UNIVERSITY VILLAGE

DESIGN RECOMMENDATION MEETING
OCTOBER 20TH, 2008

October 13, 2008
Project 208373.00

ISSUES FROM EDG
BUILDING 1

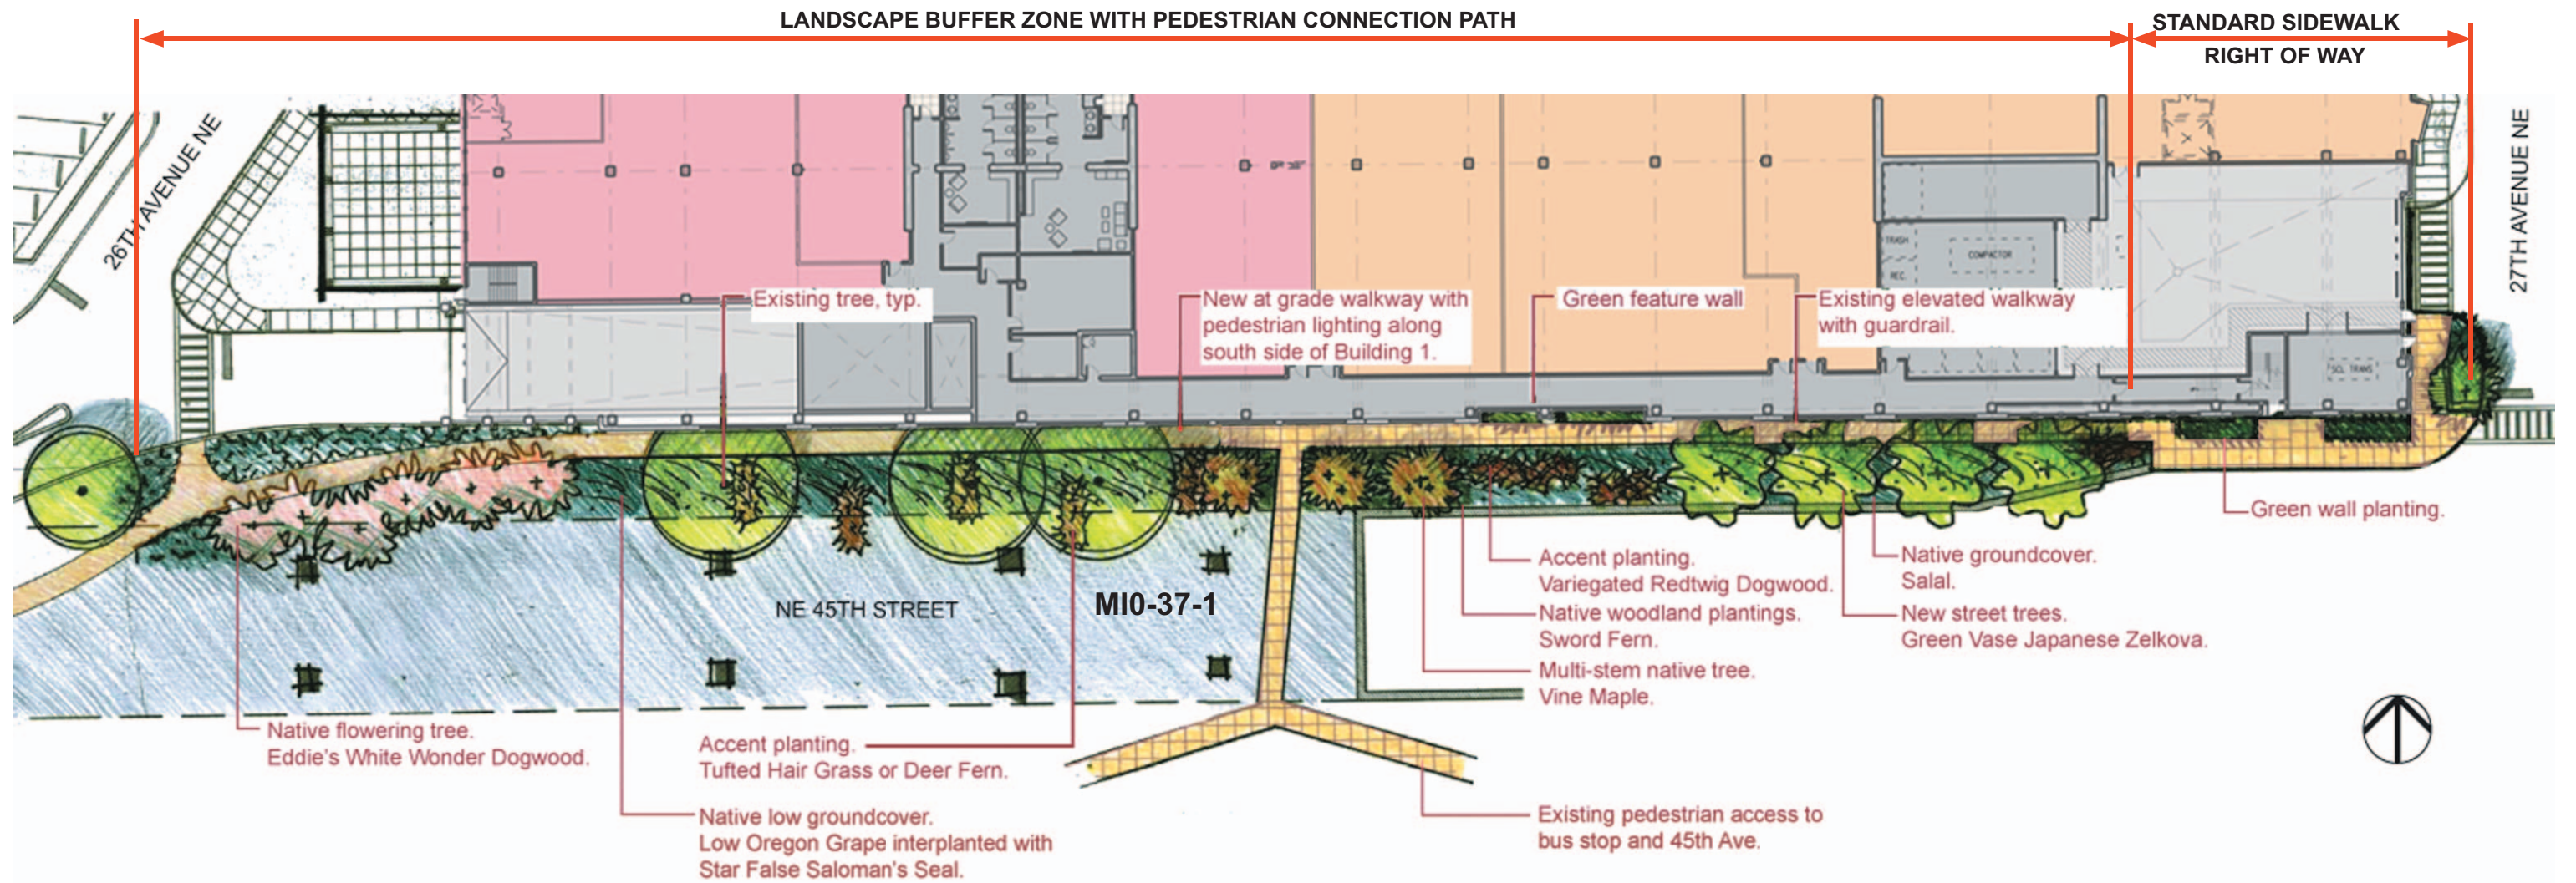
HB ● A Consider stepping down the mass with the elevation of the 45th Street viaduct: consider pulling back the top floor plates to create a terracing effect.

HB ● B Consider modulating the south wall with inset sections at least five feet deep, combined with use of color and material to visually enhance any proposed modulation.

HB ● C Provide a significant visual break in the building at street level to reduce the appearance of the length of the building.

HB ● D On the south facade, consider incorporating materials and architectural treatments to reflect the context of nearby development in the neighborhood.

HB ● E Other possible methods to reduce bulk and scale include providing building openings, transparency at the ground floor on all sides, use of various colors and materials and landscaping.

- HB ● The proposed development will reduce visual open space, replacing surface parking with structures. The proposed open space associated with the new structures should therefore be functionally usable and connected to other well used open spaces

- HB ● A Provide a pedestrian path through proposed Building 1, if at all possible. This path could coincide with a visual connection through the University Village site, which would also assist with reducing the scale of Building 1.

- HB ● B Provide a physical pedestrian connection from the walkway under the viaduct to the west. This may be in public right of way in coordination with SDOT, or it may be located on subject property.

Terracing the top level back at the east end of the building helps to reduce the perceived bulk and mass of the building along the viaduct.

The façade articulation creates the impression of multiple buildings. This breaks the horizontal massing into smaller, vertically oriented, segments, thereby reducing the perception of mass and bulk.

The façade has significant modulation (up to 4' in depth) providing a visual break in two locations along its length.

Bulk and scale mitigation at the base of the building is achieved using a combination of transparent elements such as glass block and display windows, bay and texture articulation in the split faced block, and the introduction of significant landscape elements in the right of way.

The proposed walkway connects with primary pedestrian pathways at both the east and west ends of Building 1.

Improved pedestrian connections and wayfinding along the south edge of the building connecting to the path under the viaduct with a well-lit walkway set in significantly enhanced landscaping.

A pedestrian connection through the center of the building is not desirable from a wayfinding and pedestrian experience standpoint. It would be difficult to provide adequate pedestrian amenities through service areas and would create a security concern.

BUILDING 1 STREET LEVEL
DEVELOPMENT STANDARDS
DEPARTURE

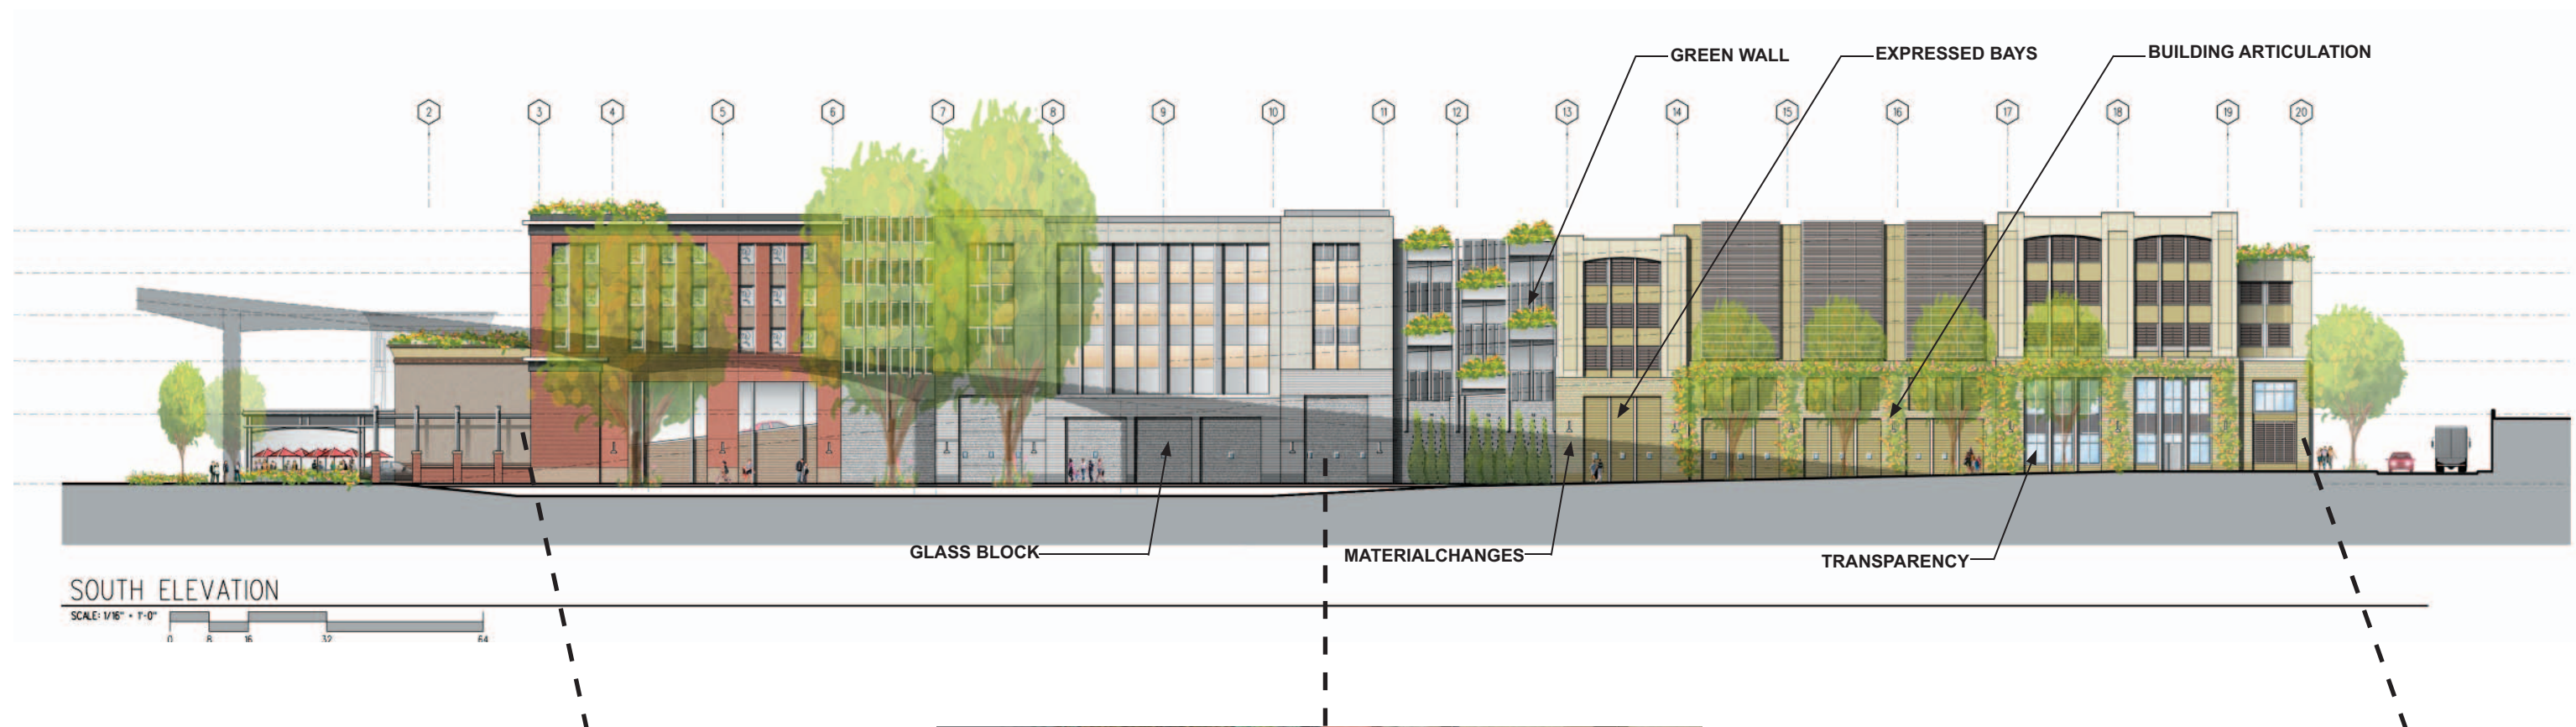
This departure will address the blank façade and transparency requirements of this section. University Village proposes that the unique site conditions created by the above-grade viaduct along the south side of Building 1 are best addressed by the following design approach:

- Where the building addresses a standard sidewalk condition along NE 45th Street at the east end of the building, display windows have been incorporated into the façade to introduce transparency and address the blank façade requirements.

- Where the viaduct begins to be elevated and the standard sidewalk right-of-zway does not exist, a pedestrian connector path has been incorporated into an improved landscape buffer zone in the SDOT right-of-way adjacent to and under the viaduct. In addition, the proposed design includes significant articulation of the building façade along the south base of the building—modulating the surface to express structural bays and introducing glass block patterning in the split face block wall which will glow at night.

- The pedestrian experience through the improved landscape area will be enhanced with appropriate pedestrian lighting and clear wayfinding elements.

ISSUES FROM EDG
BUILDING 2

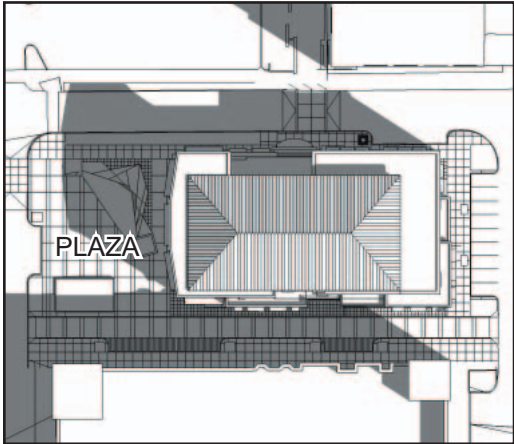
Demonstrate the south wall of Building 2 would include quality finishes and not represent a blank wall

HB ● The proposed development will reduce visual open space, replacing surface parking with structures. The proposed open space associated with the new structures should therefore be functionally usable and connected to other well used open spaces

The feature plaza has been placed directly in front of the building. The proposed design includes removing the featured stair element, and deleting the parking spaces shown west of the building per the DRB recommendation.

There is no longer an exterior stair along the south wall of Building 2 which has been designed with significant façade articulation.

ISSUES FROM EDG
GATEWAY BUILDING

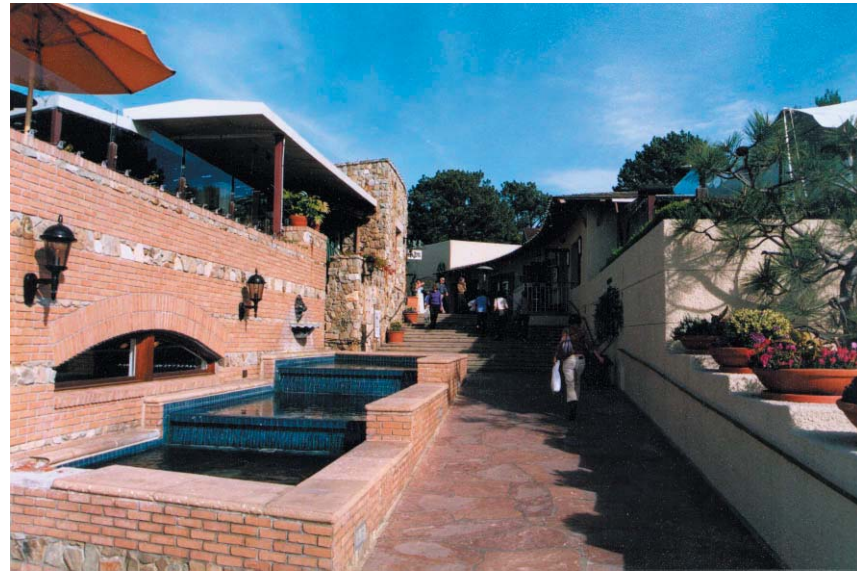
The proposed design should include maximum transparency adjacent to the sidewalk at the north and west facades, and include articulation and modulation to reduce the height and scale of the north facade.

The west facade of Building 3 should respond to newer architectural styles within the area

The proposed design of Building 3 should include attention to both the northwest and southwest corners of the building.

HB The plaza to the interior of the site should be larger than the plaza on 25th and be more pedestrian focused. The Applicant should clearly demonstrate how the proposed loading area and vehicle access at Building 3 will not conflict with the pedestrian oriented open space, and how the open space will have clear pedestrian connections to existing sidewalks and stairways nearby

Significant corner element on the northwest corner of the building responds to view corridors and creates an appropriate gateway marker for pedestrian and vehicular circulation from 25th Ave NE into University Village.

The retail at the gateway corner is clearly visible with a highly transparent corner set approximately five feet above sidewalk grade.

The five foot base condition is mitigated by setting the building back from the sidewalk and providing a significant landscape buffer.

Maximum transparency has been provided along the north face of the building and the building edge has been pulled back to allow for a landscape buffer where transparency cannot occur at grade.

The scale of the plaza on the 25th Ave NE side has been reduced and access enhanced with an accessible route from the sidewalk through a landscape buffer. The plaza helps provide a clear pedestrian connection from the upper level retail to the lower level retail.

Building 3 has been reduced in height by one level mitigating the concern about the height and scale of the north façade.

The loading dock entrance has been moved to the center of the block. This allows for a clearly defined pedestrian plaza in an ideal relationship with the adjacent retail and the access stairs to the upper level of retail. The loading dock access will be closed off with a decorative gate when not in use.
